El Paso County
STORMWATER MANAGEMENT PLAN

Short Stop Restaurant
Part of Lot 1, Powers Centre Filing No. 3
Section 6, Township 14 South, Range 65 West of the 6th P.M.
5819 Palmer Park Boulevard

Revised
November 28, 2018

SUBJECT: Stormwater Management Plan
Short Stop Restaurant

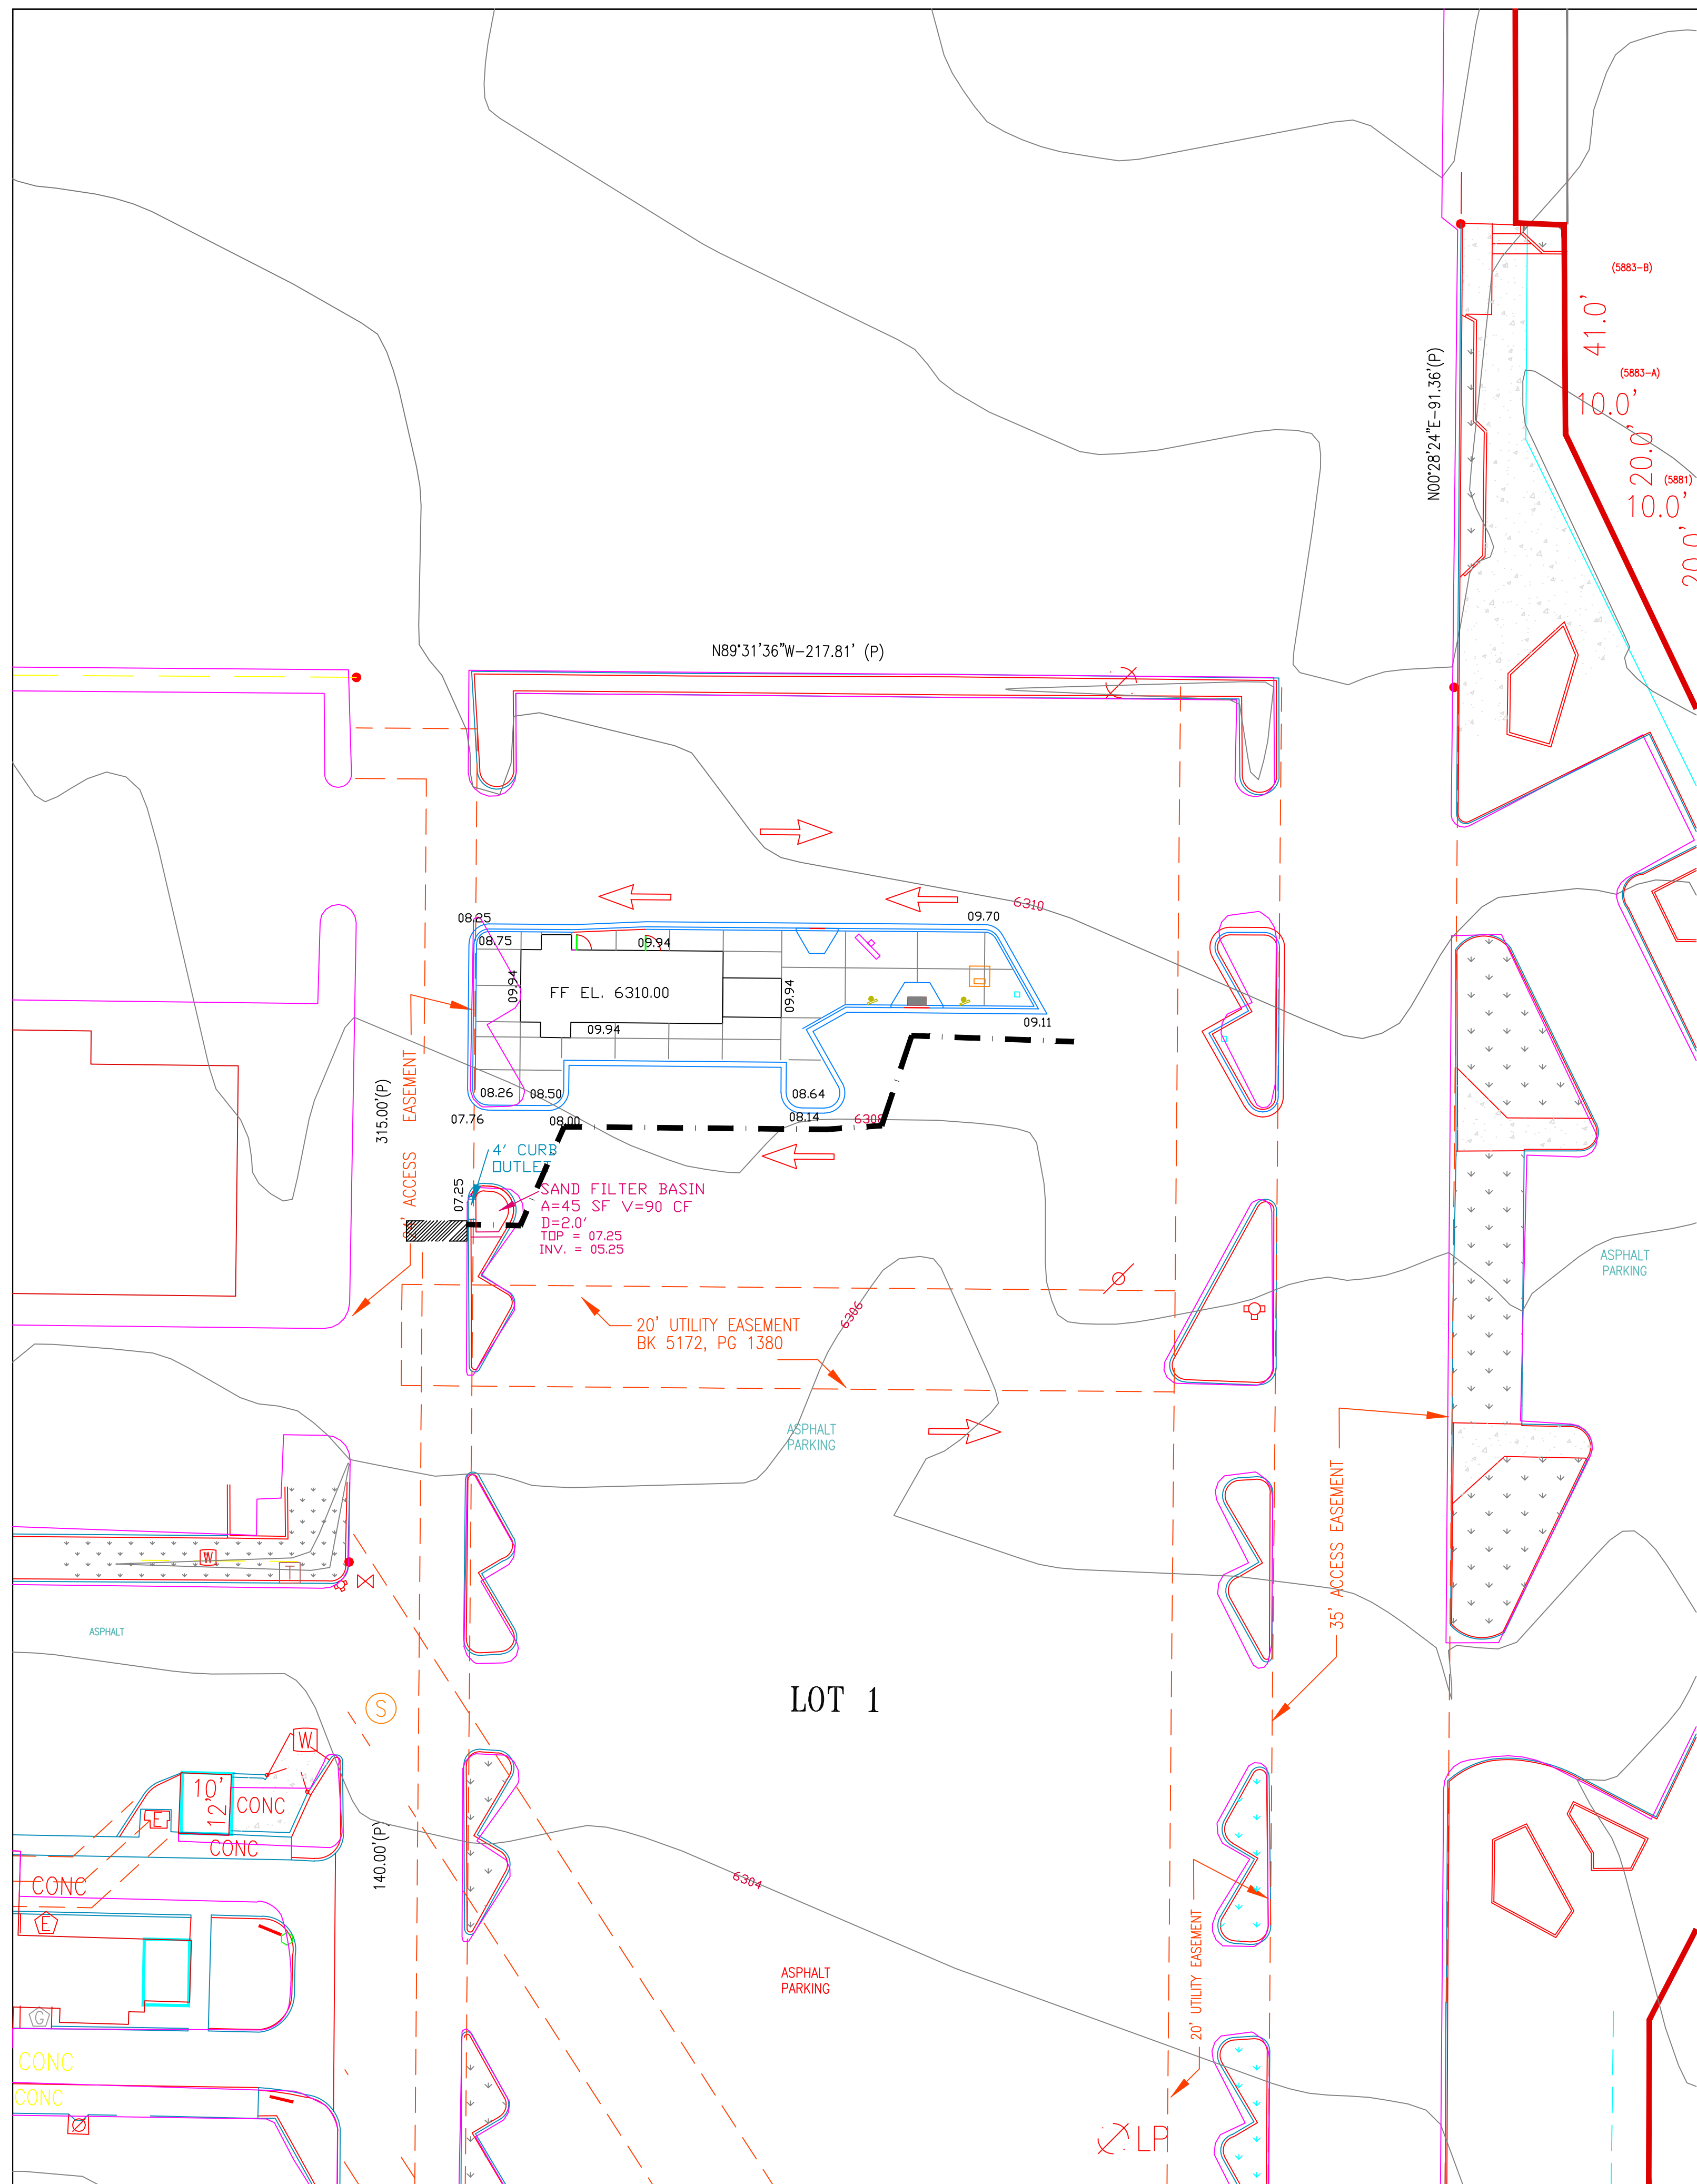
•Please provide a complete Grading and Erosion Control Plan with El Paso County Standard Grading and Erosion Control Plan notes and standard signature blocks.

•The Grading and Erosion control plan is required to meet all items on the El Paso County Grading and Erosion Control submittal checklist found in appendix E of the ECM. If an item from the checklist is not applicable please state it on the plans.

Show concrete washout area on the plan and provide a detail of it. Also please show the staging area.

Please provide a complete Grading and Erosion Control Plan with El Paso County Standard Grading and Erosion Control Plan notes and standard signature blocks.

- Please provide a complete Grading and Erosion Control Plan with El Paso County Standard Grading and Erosion Control Plan notes and standard signature blocks.
- The Grading and Erosion control plan is required to meet all items on the El Paso County Grading and Erosion Control submittal checklist found in appendix E of the ECM. If an item from the checklist is not applicable please state it on the plans.

Show concrete washout area on the plan and provide a detail of it. Also please show the staging area.

Show concrete washout area on the plan and provide a detail of it. Also please show the staging area.
